SUBJECT: PLANS AND PROPOSAL ADDENDUMS

PROJECT: F 2B24(123)

CONTROL: 0814-01-036

**PROPOSAL ADDENDUMS**

**FM 422  
 CULVERT  
 PROFILES**

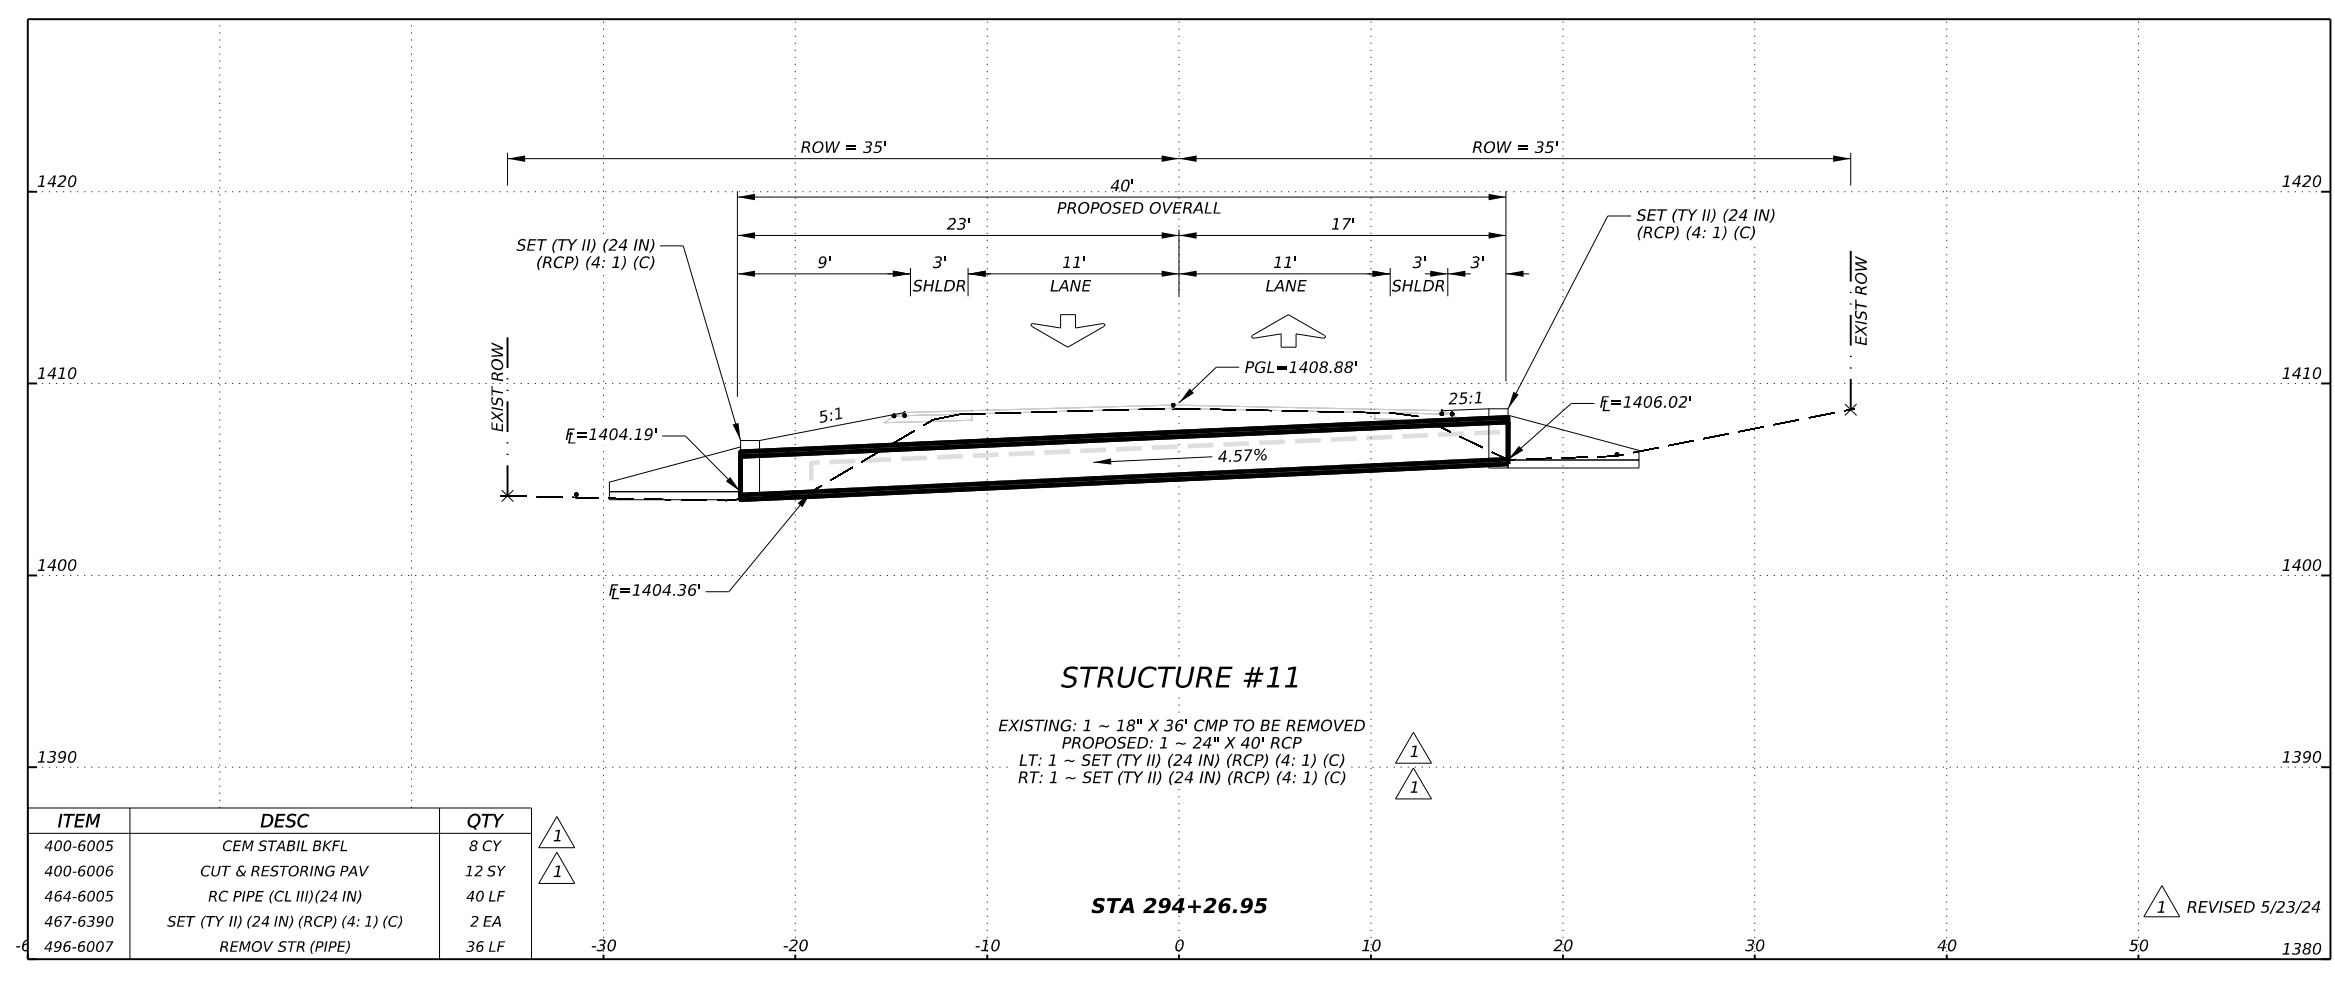
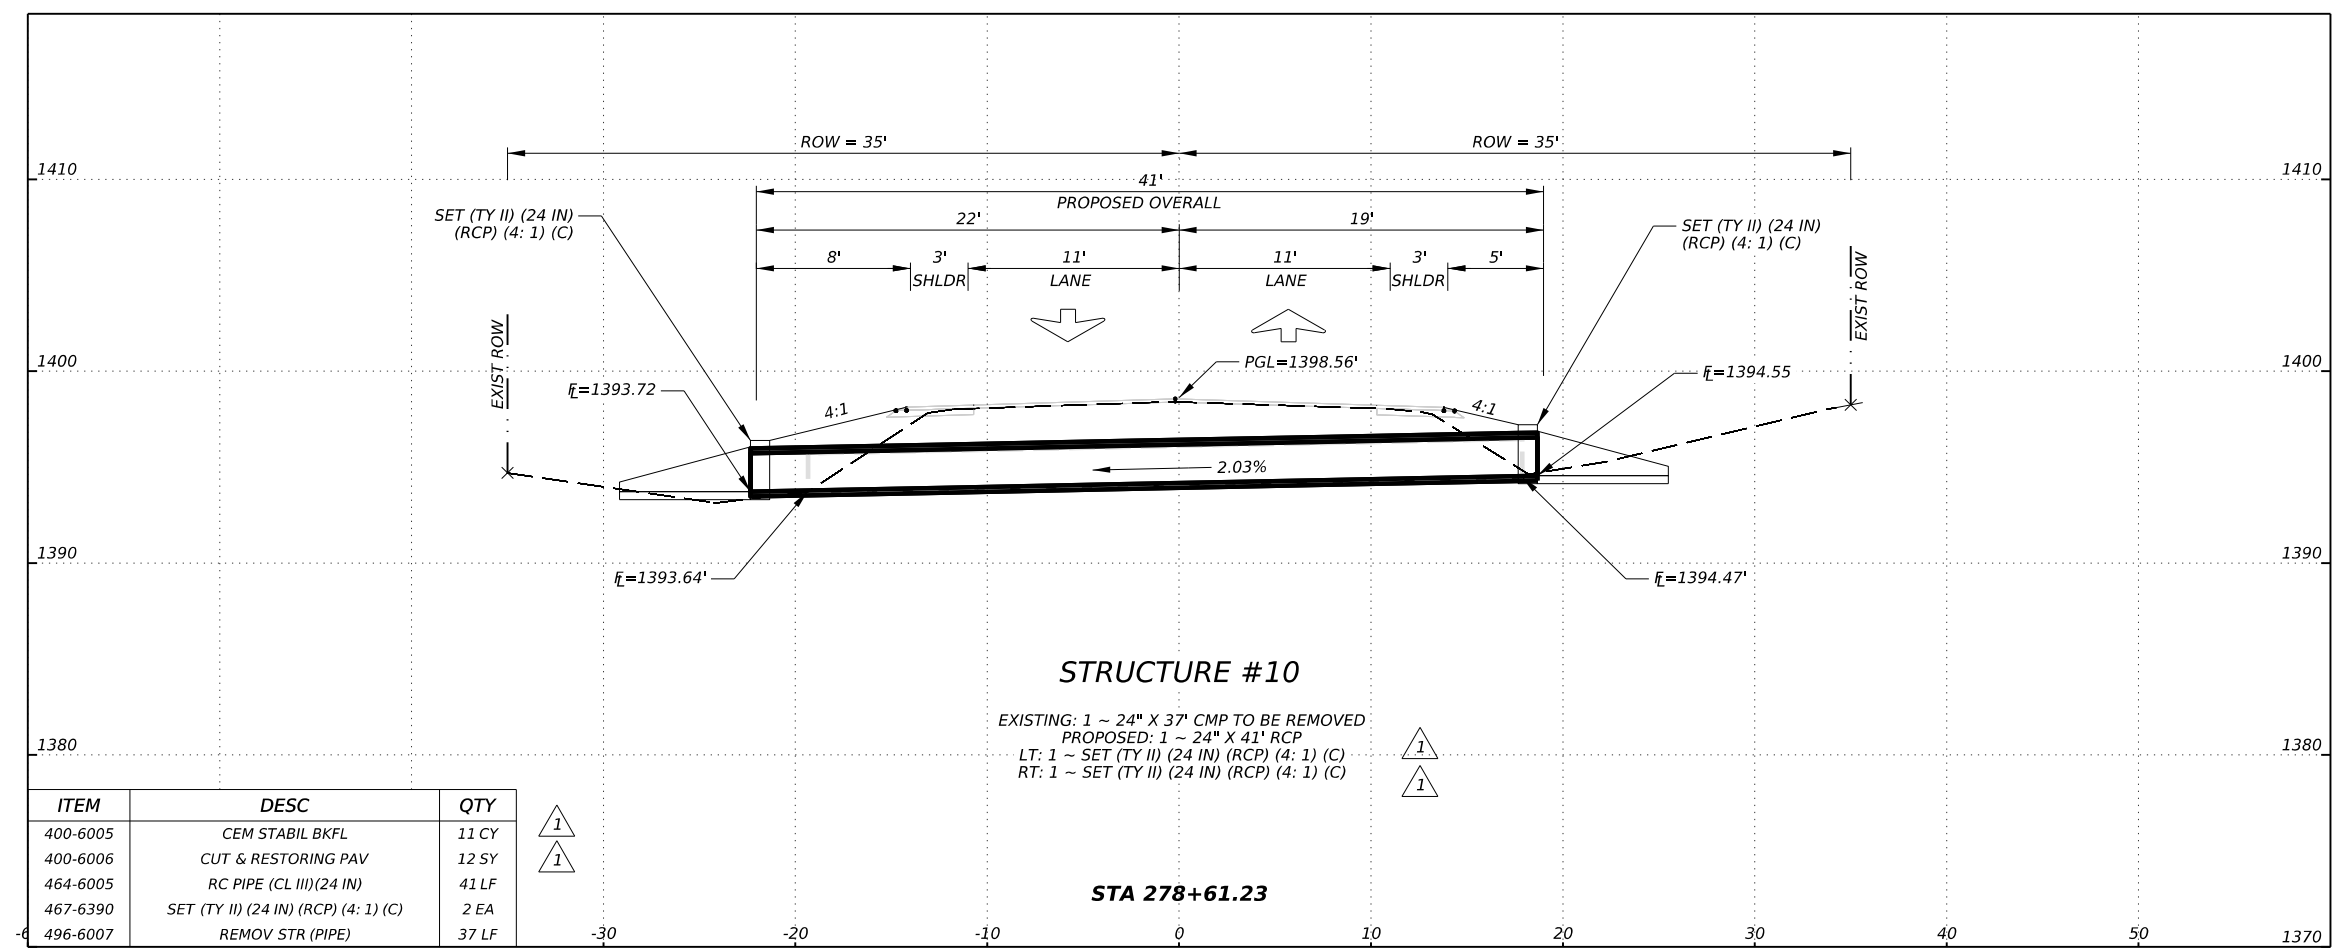
REVISE SHEETS 8, 11-12, 13-15, 74, and 76-82, DUE TO CHANGES ABOVE

REVISED 5/23/24

**FM 422  
CULVERT  
PROFILES**

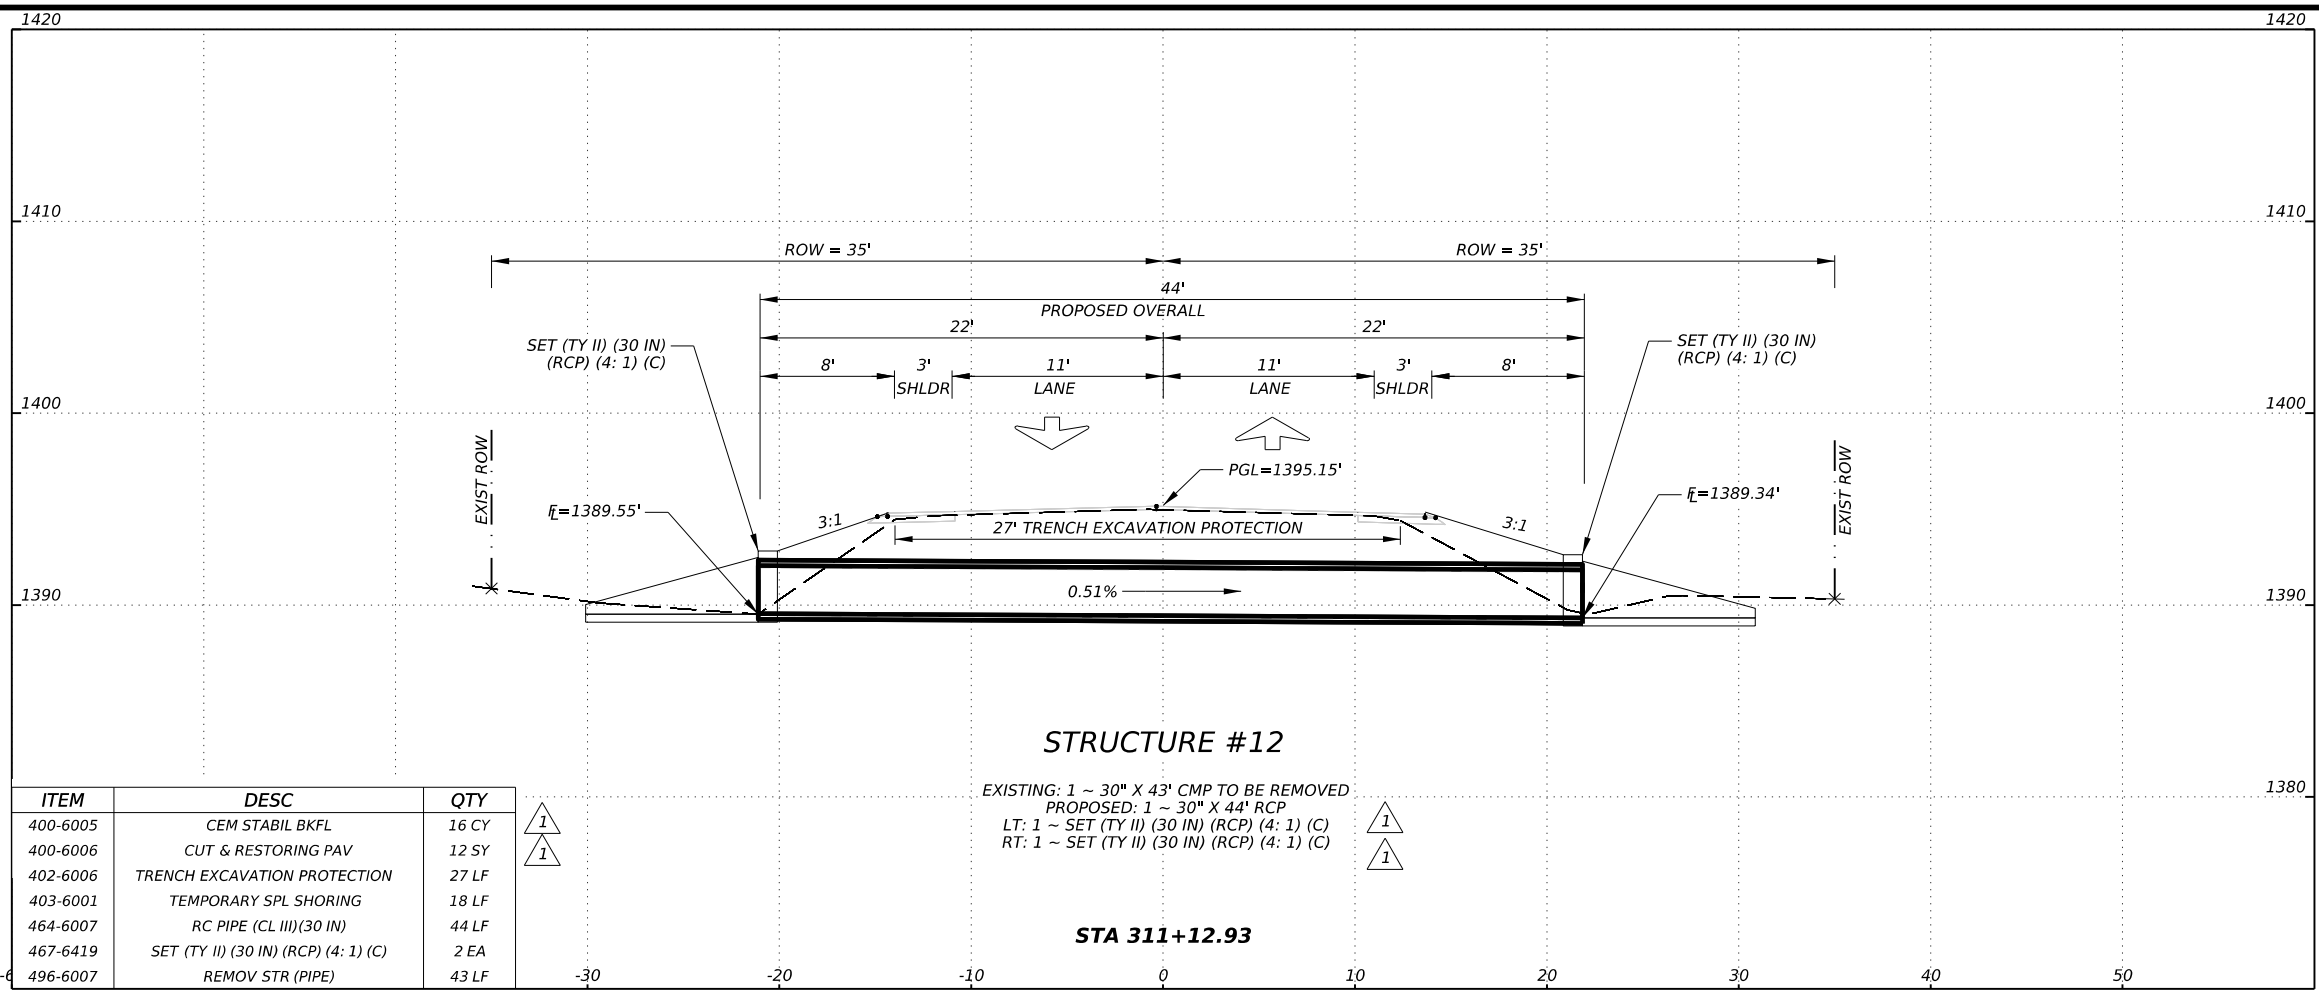
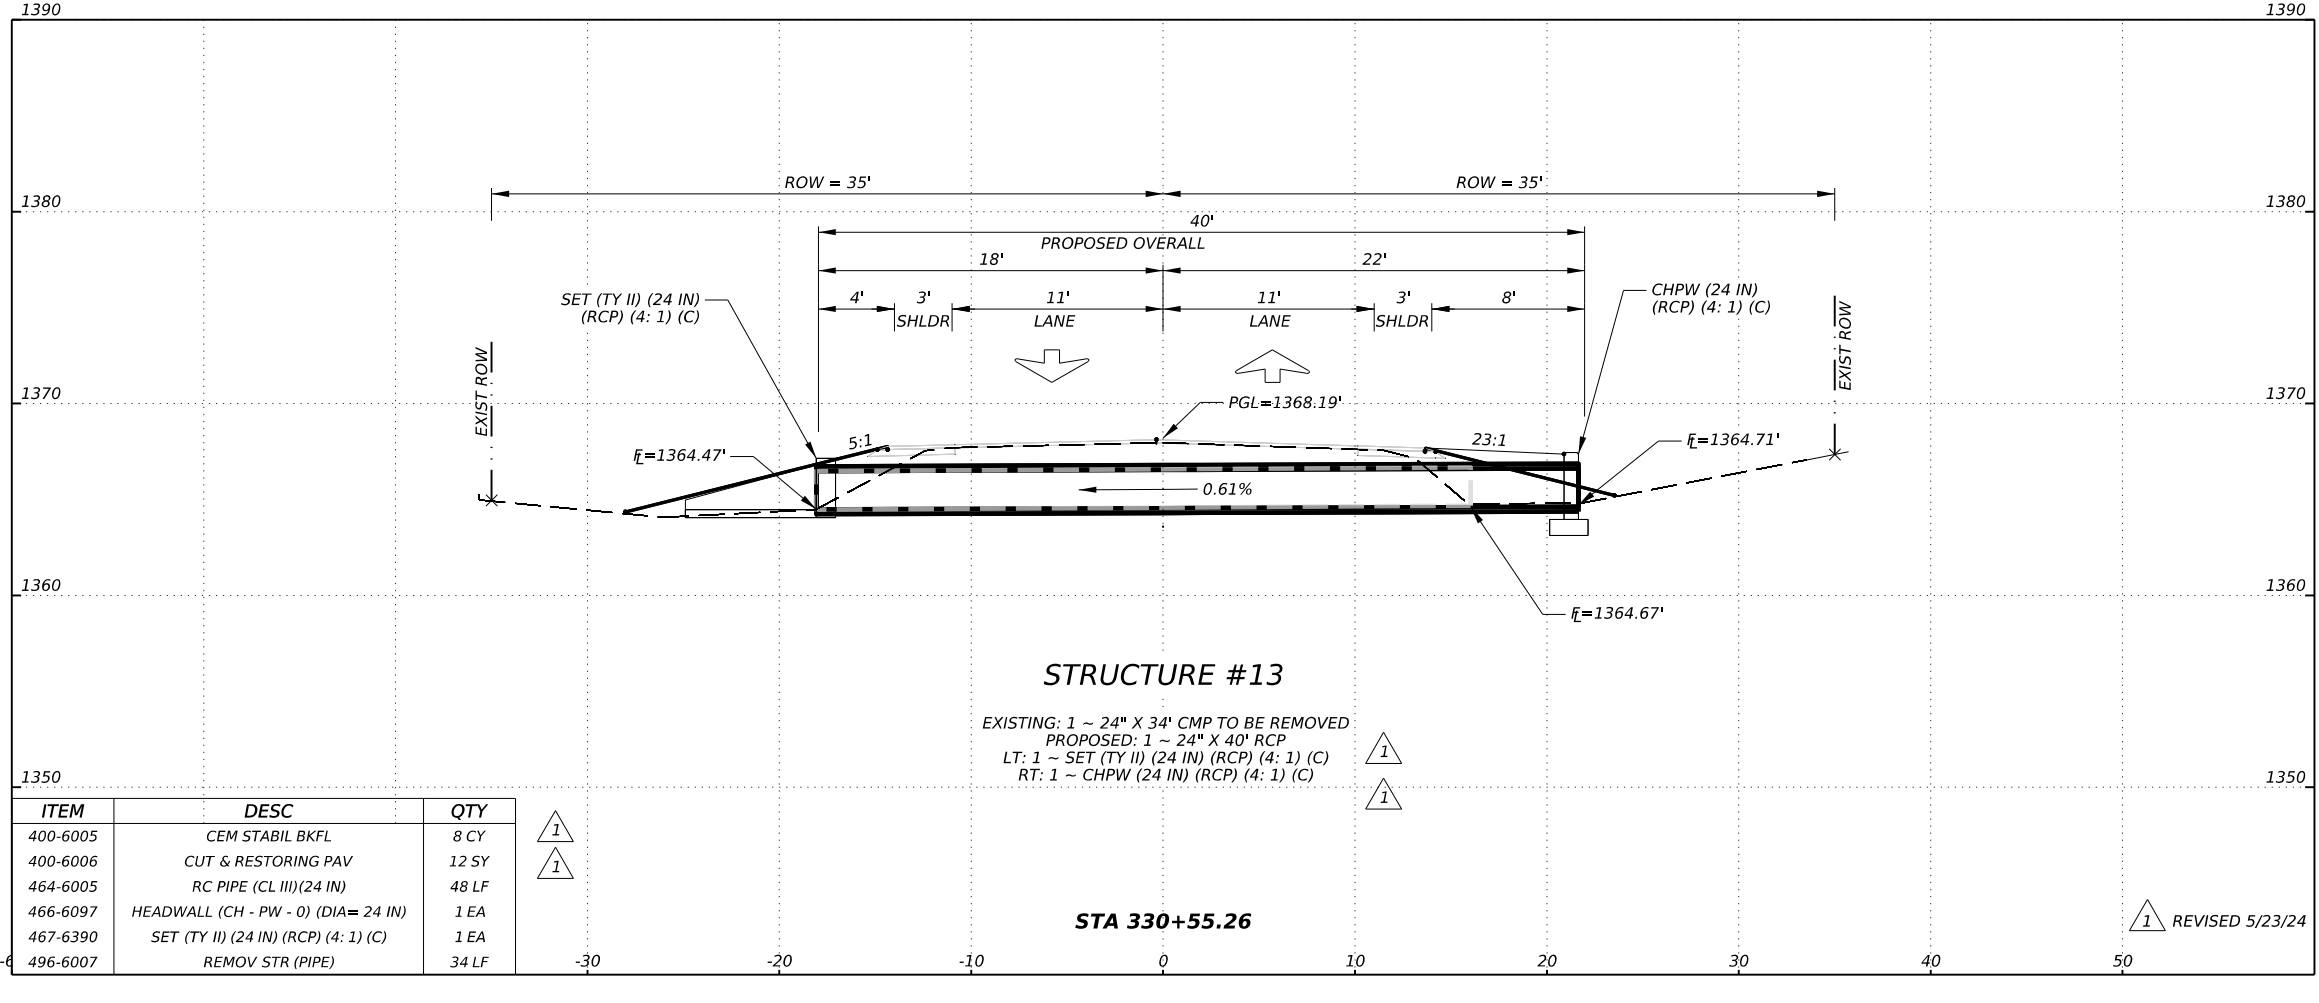
REVISED 5/23/24

ITEM	DESC	QTY
400-6005	CEM STABIL BKFL	16 CY
400-6006	CUT & RESTORING PAV	12 SY
402-6006	TRENCH EXCAVATION PROTECTION	27 LF
403-6001	TEMPORARY SPL SHORING	18 LF
464-6007	RC PIPE (CL III)(30 IN)	44 LF
467-6419	SET (TY II) (30 IN) (RCP) (4: 1) (C)	2 EA
496-6007	REMOV STR (PIPE)	43 LF

ITEM	DESC	QTY
400-6005	CEM STABIL BKFL	8 CY
400-6006	CUT & RESTORING PAV	12 SY
464-6005	RC PIPE (CL III)(24 IN)	48 LF
466-6097	HEADWALL (CH - PW - 0) (DIA= 24 IN)	1 EA
467-6390	SET (TY II) (24 IN) (RCP) (4: 1) (C)	1 EA
496-6007	REMOV STR (PIPE)	34 LF
